ISSUE: Certificate of Appropriateness for new construction

APPLICANT: City of Alexandria and Washington Metropolitan Area Transit Authority (WMATA)

BAR#2019-00241
2901 Potomac Ave. (2405, 2501, and 3701 Potomac Ave., 3251 Potomac Ave.
[Parcel ID 016.04-01-01], 700 Carpenter Rd, 1702 & 1880 Potomac Greens Dr.)

**Contract No. FQ16146 - Washington Metropolitan Area Transit Authority
(WMATA) Potomac Yards Metrorail Station
LTR-0104-PM-City of Alexandria January 22nd, 2020 BAR Submission**

4 DOWNSPOUT PLATFORM PLAN
1 1/2" = 1'-0"

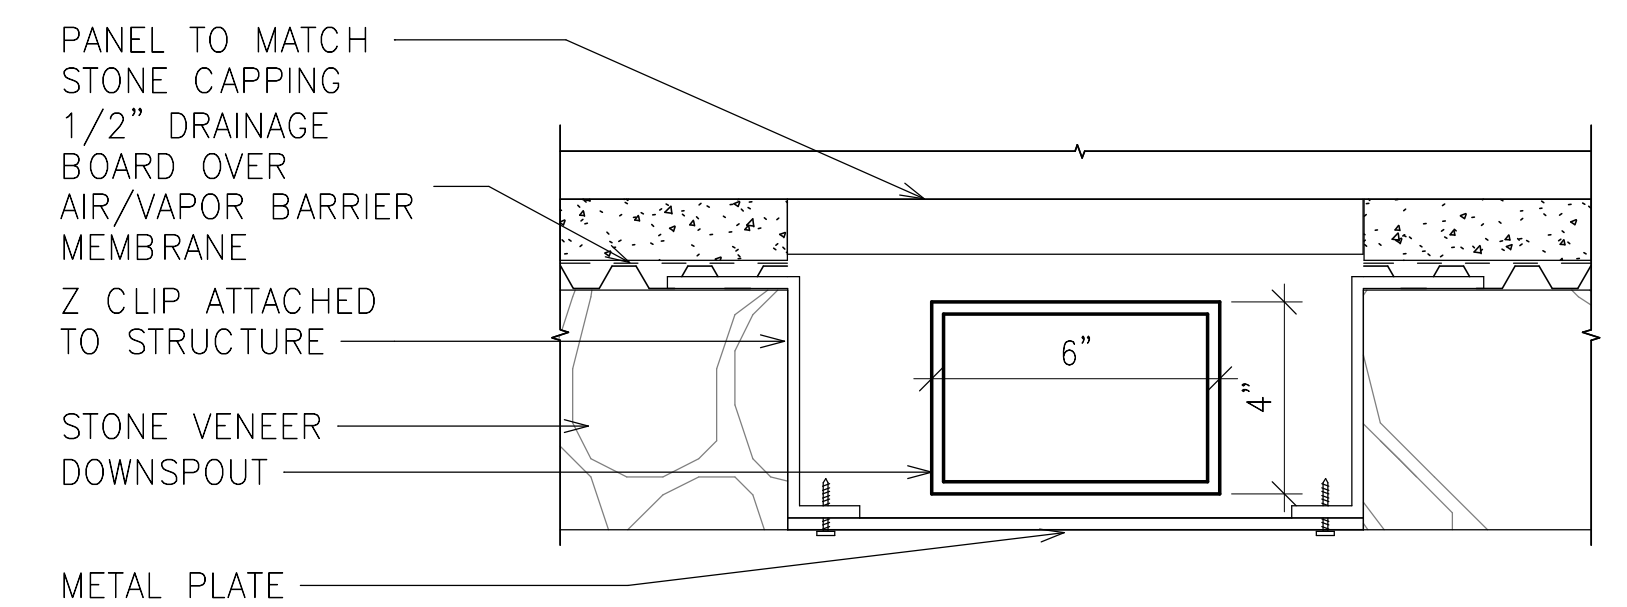
The downspouts, cleanouts and transition to the underground drainage pipe are hidden behind metal cover plates at the battered stone base. These cover plates will have a return on each side that will slip into the stone notch and provide rigidity for the plates. There will be a sloped collar transition at the top of the cover plate that will surround the downspout and rise to the level of the bottom of the coping at the back of the notch.

The final detail that the BAR discussed is the color of the downspouts where they visually conflict with the abutting structural member. This color will have to change when the angled downspout attached to a light grey roof truss member is then attached to a vertical portion of the dark brown color exoskeleton. The downspouts will be prefinished and the color changes will occur at a joint. In general, staff recommends that the downspouts at the platform match the Wickham Gray color of the roof steel structure and the downspouts and cover plates at the stone base match the darker gray Pussy Willow of the steel columns and field stone base. Anywhere the downspout is attached to the Chocolate Brown Met color exoskeleton, should be painted the same brown color. These conditions will be verified by staff in the wall mockup, the construction drawings and in the field.

1. Approval of the downspout details with the color of the downspouts to match the adjacent structural feature and final review of the cover plate details by staff; the Chocolate Brown Met color flat exoskeleton finish; and the guardrail and stone retaining wall, as submitted.
2. Deferral of the cast stone details and west elevation of the entrance pavilion on the west side of the tracks, the glass handrail/guardrail details in the station and exoskeleton connection details.

Item 6 – Simulated Weathered Steel

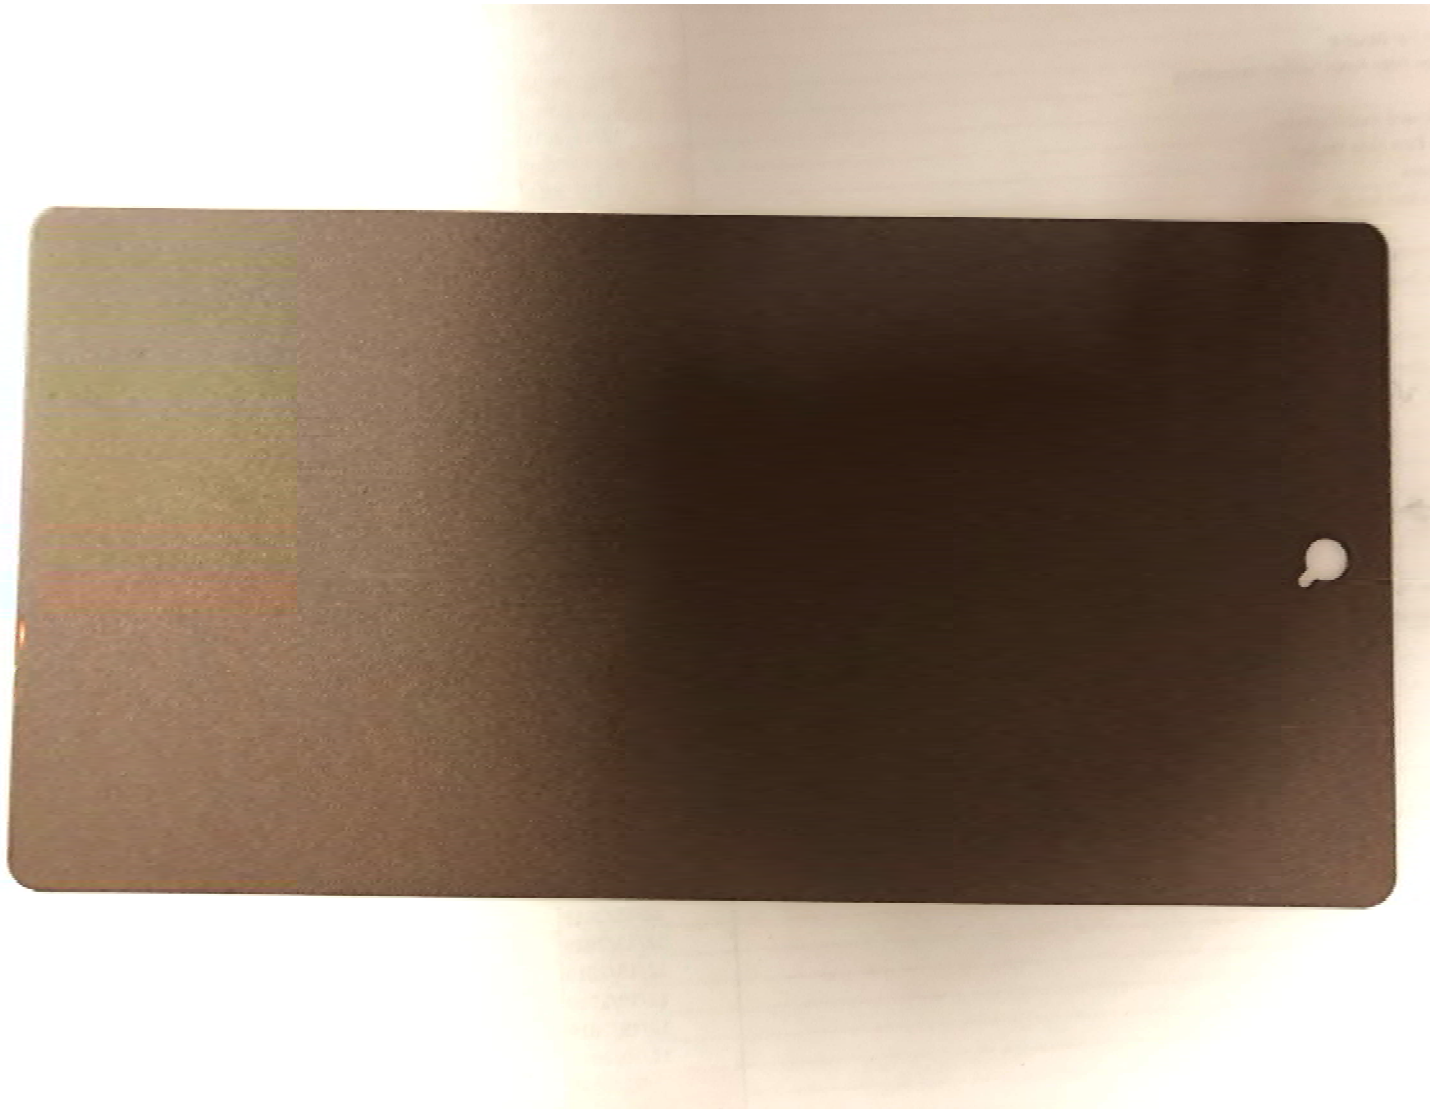
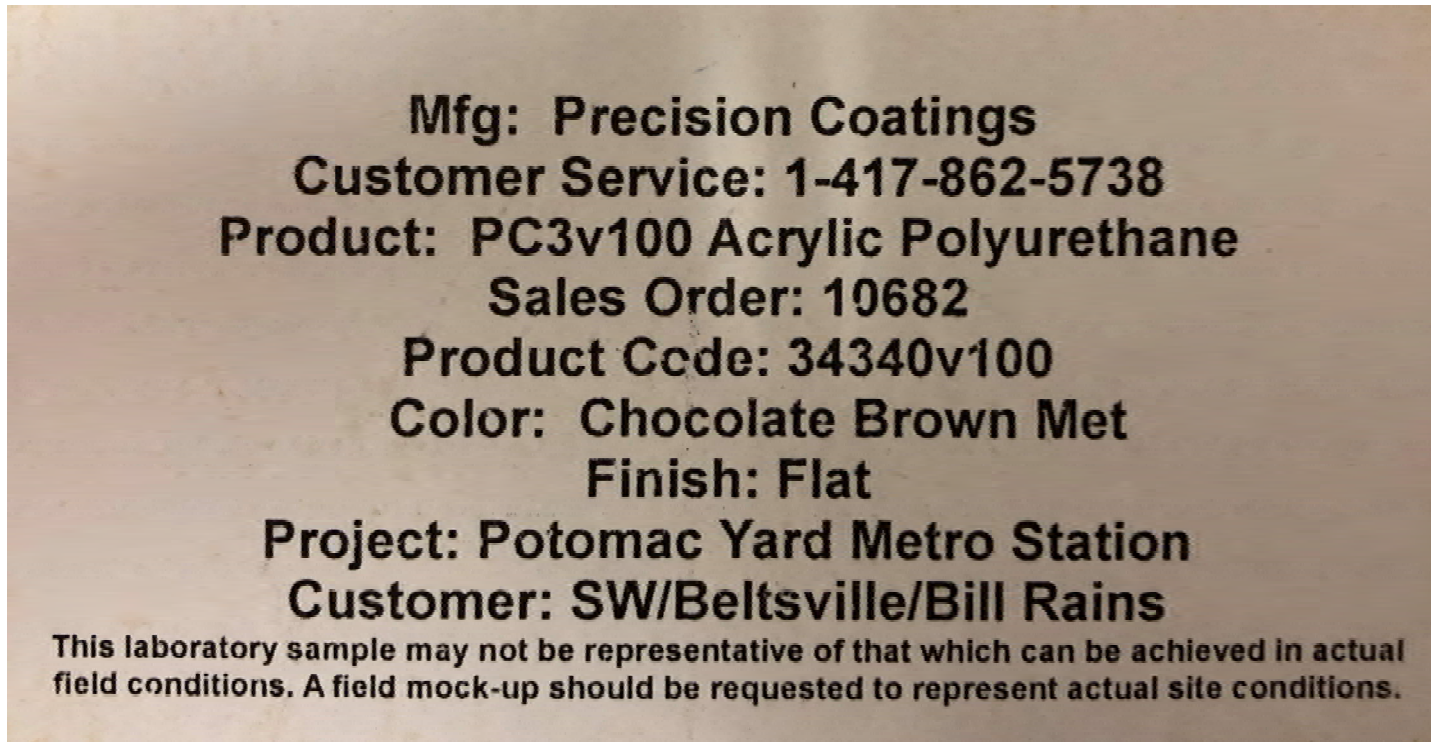
During concept review for this project, the BAR recommended a naturally weathering steel finish for the exoskeleton in order to blend with the natural environment at the GW Parkway. City and WMATA staff have reviewed several submissions from the applicant and agree that the Chocolate

Brown Met color by Precision Coatings is the best alternative. This Acrylic Polyurethane has a flat, slightly metallic finish that varies in different light conditions. Tests indicate it is durable and can be repaired in the field. A sample of the color will be available at the hearing. Staff finds this finish to be the closest to the character that the BAR originally requested and recommends its approval.

Item 7f – East Guardrail Details

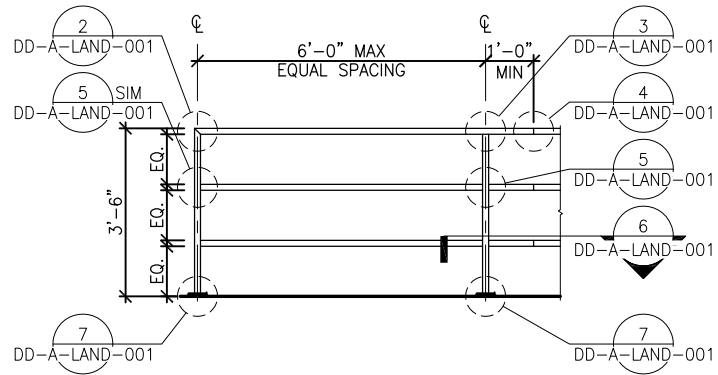
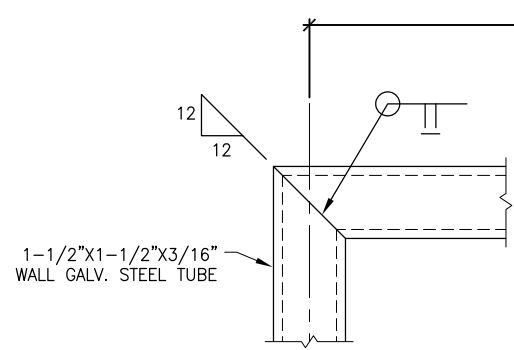
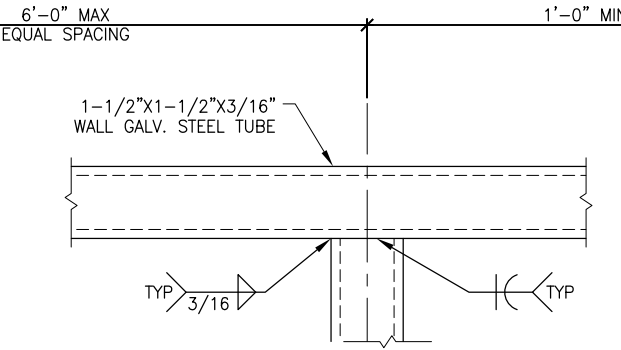
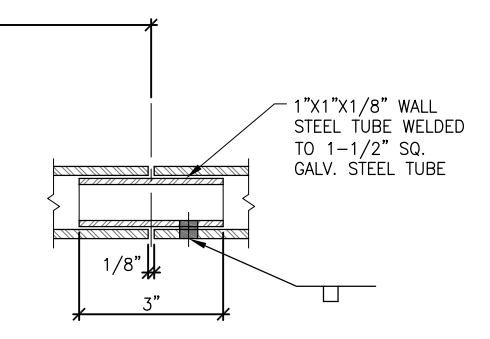
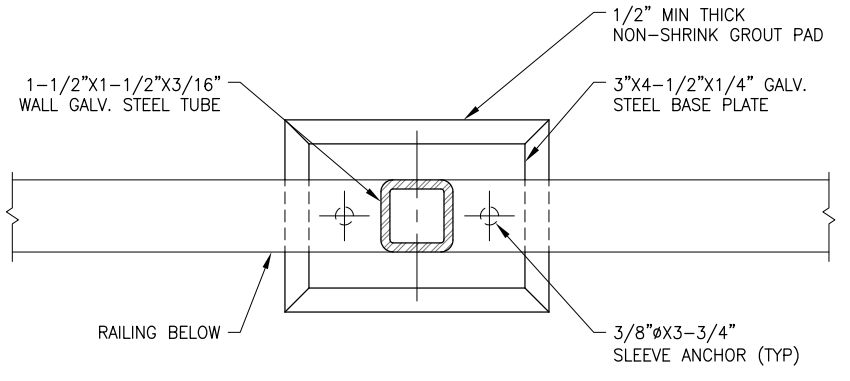
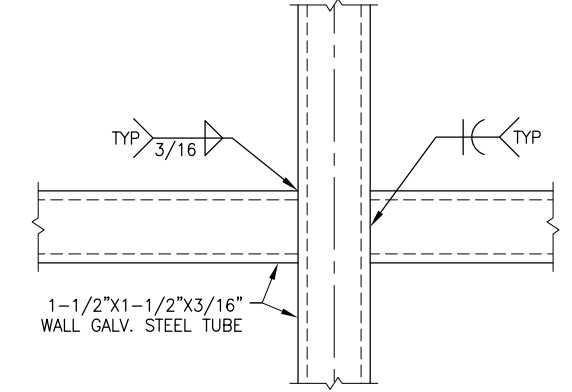
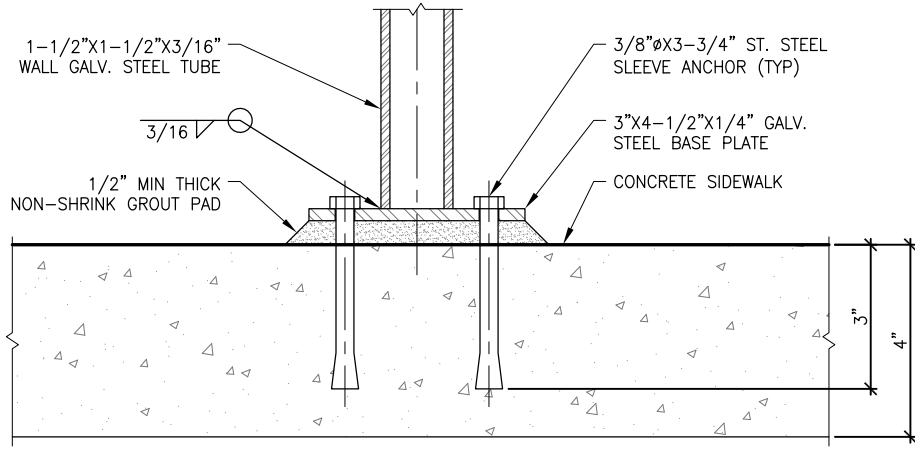
After working with the National Park Service, the form of the retaining wall changed from a steep berm held by a fabric mesh to a structural retaining wall (see the retaining wall description in the section below.) The applicant originally proposed a utilitarian highway department style galvanized steel guardrail and then a split rail wood fence to address the concerns of the BAR for bicyclist and pedestrian safety at the edge of this drop-off. Both of these alternatives were rejected by the BAR. With the new retaining wall condition, a guardrail preventing the passage of a 4” sphere no longer a code requirement. The applicant is, nevertheless, proposing a simple steel guardrail of rectangular steel tube painted to match the brown of the exoskeleton. The intention is to blend with the exoskeleton of the station when viewed from the Parkway and blend with the woodlands when viewed from the station. Aside from the color, the railing is a standard WMATA design constructed to their standards and that can easily be repaired in the field.
